FOR THE DEPARTURES TERMINAL EXPANSION AND MODERNIZATION PROJECT

AT THE NORFOLK INTERNATIONAL AIRPORT

ADDENDUM NO. 2

RFQ-FY25-100-04

NEW CONSTRUCTION
- COLOR PLAN - FIRST
FLOOR

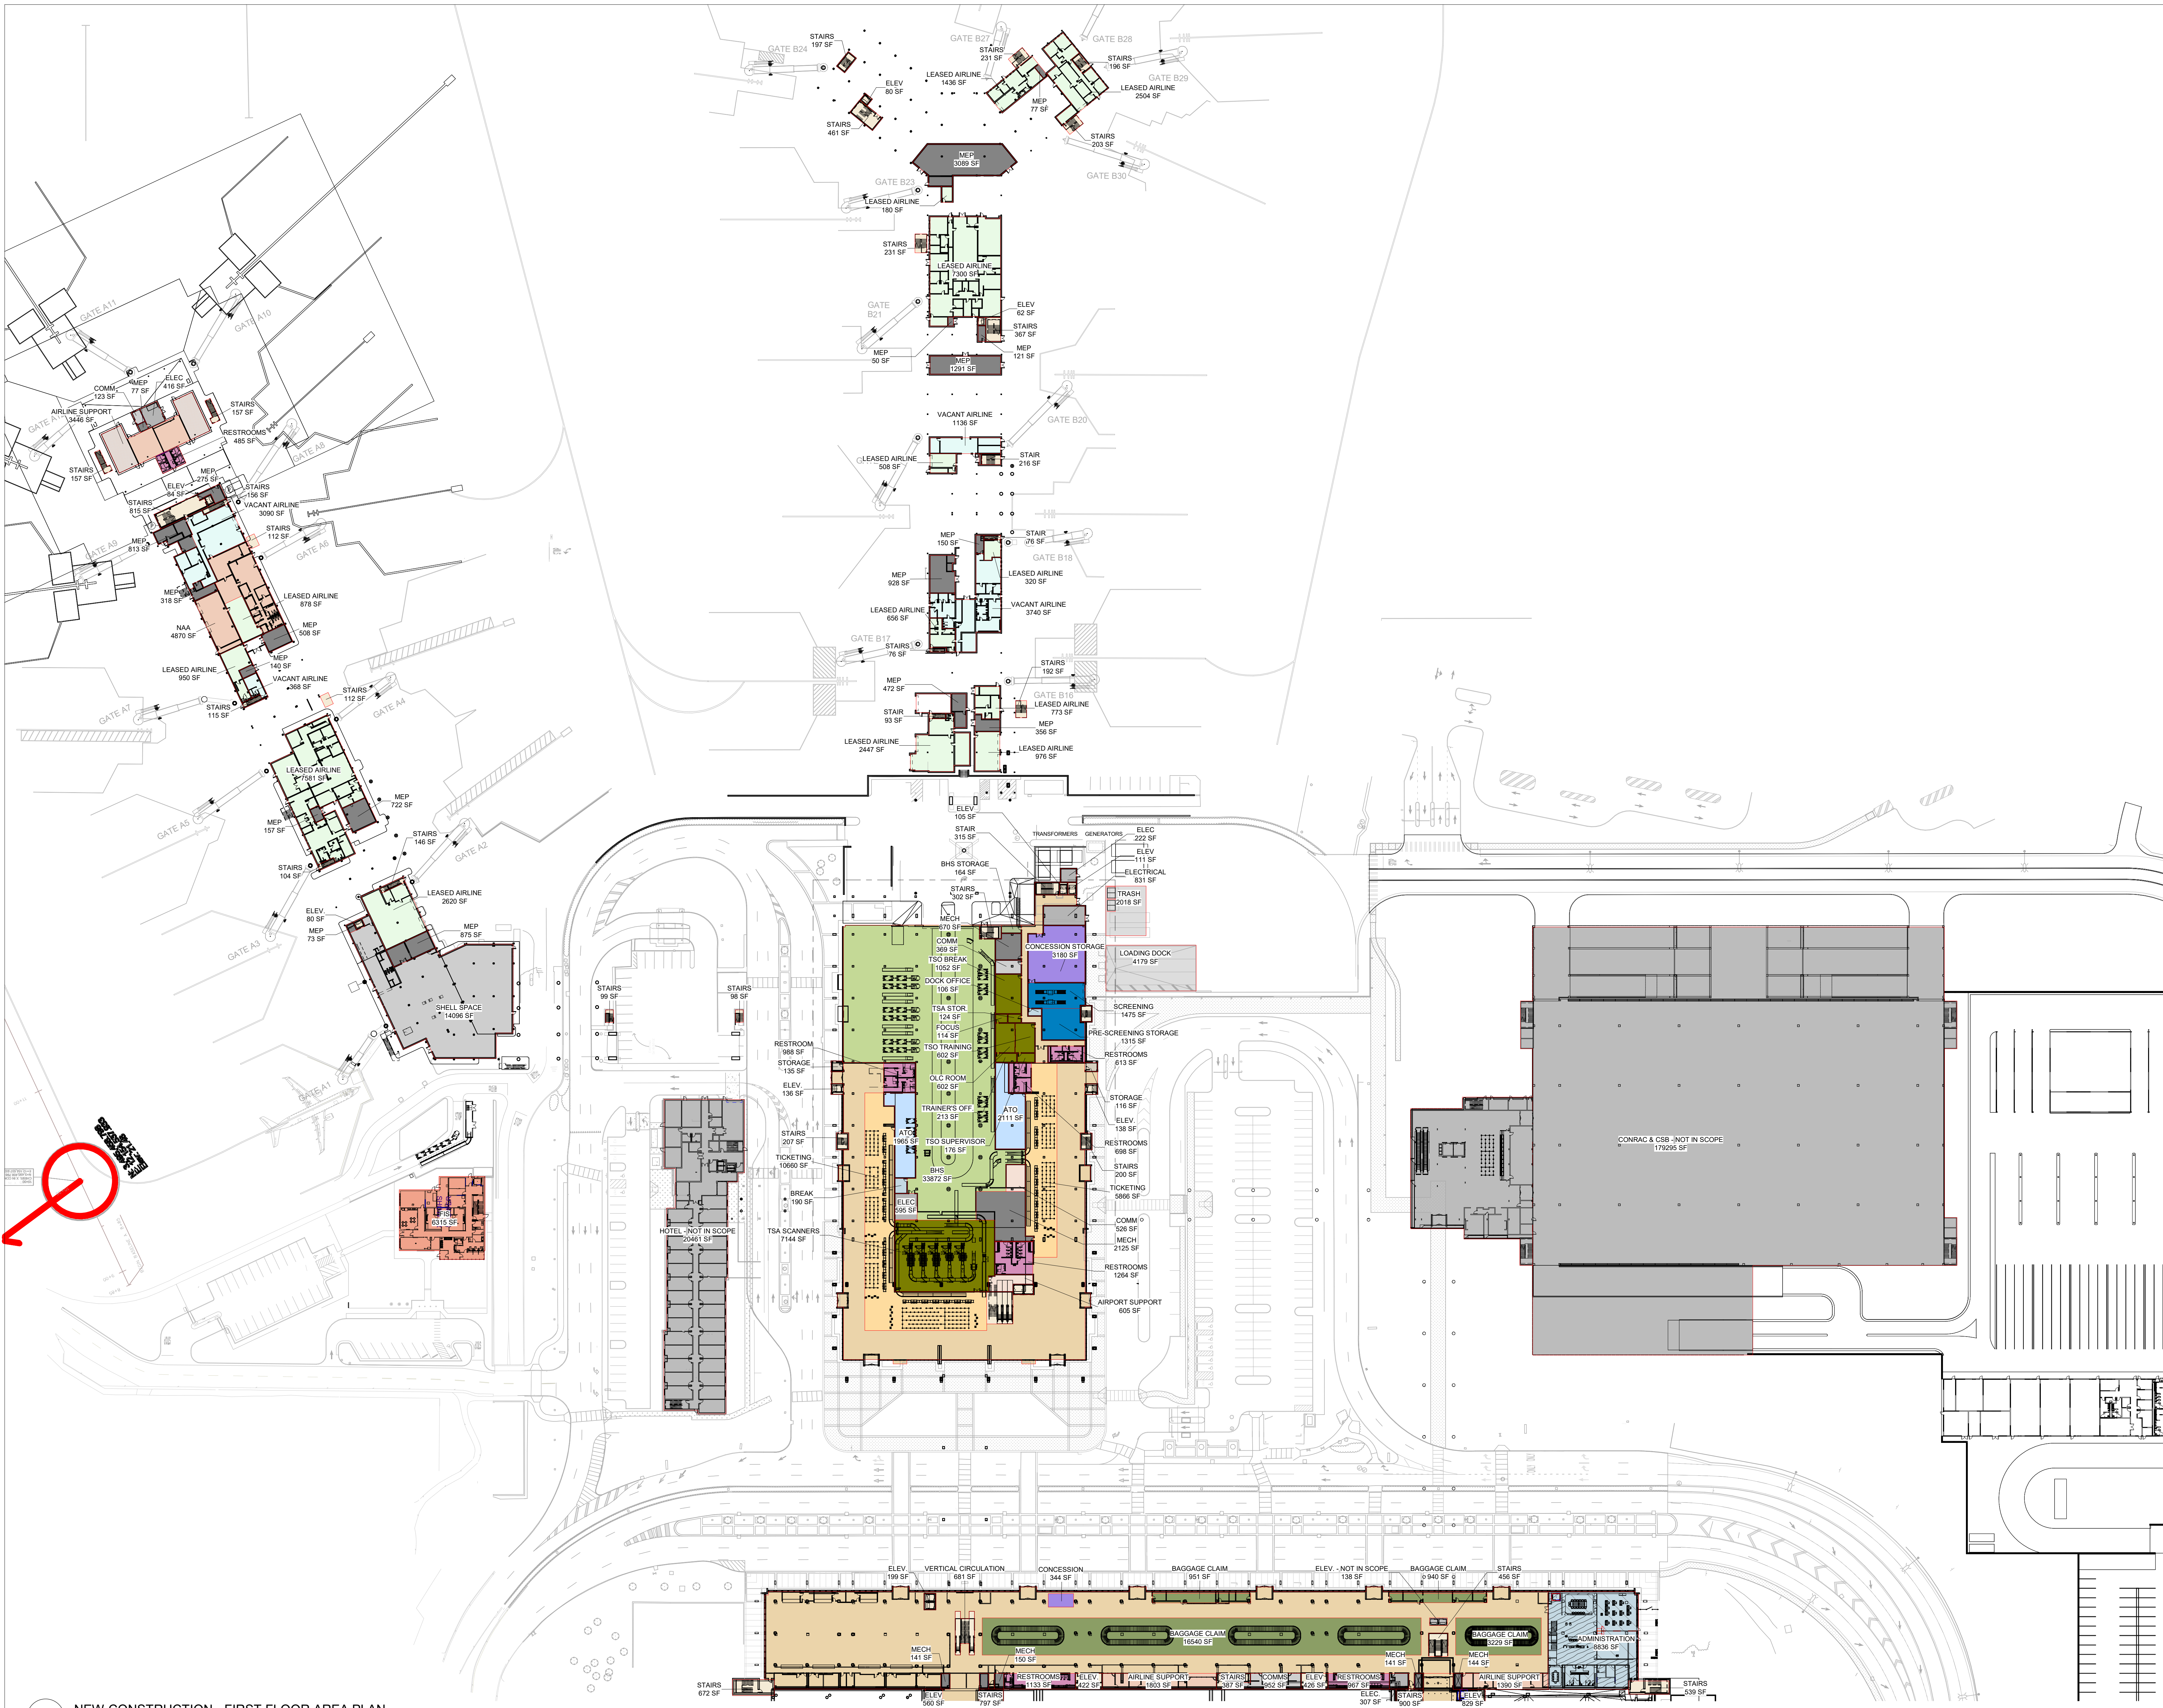
1. Remove and replace RFQ Exhibit G on page 224 of RFQ PDF with attached version
 - a. Previous version stated Authority is seeking three CCIP coverage options
 - b. Revised to state Authority is seeking two options
2. Remove First Floor Color Plans New Construction 001 on page 235 of RFQ PDF and replace with New Construction – Color Plan – First Floor A001
 - a. Previous version stated Administration Offices Not in Scope
 - b. Revised to remove Not in Scope statement
 - c. Administration Offices are in Scope of Work
3. Remove Second Floor Color Plans New Construction 002 on page 236 of RFQ PDF and replace with New Construction – Color Plan – Second Floor A002
 - a. Previous version stated Administration Offices Not in Scope
 - b. Revised to remove Not in Scope statement
 - c. Administration Offices are in Scope of Work
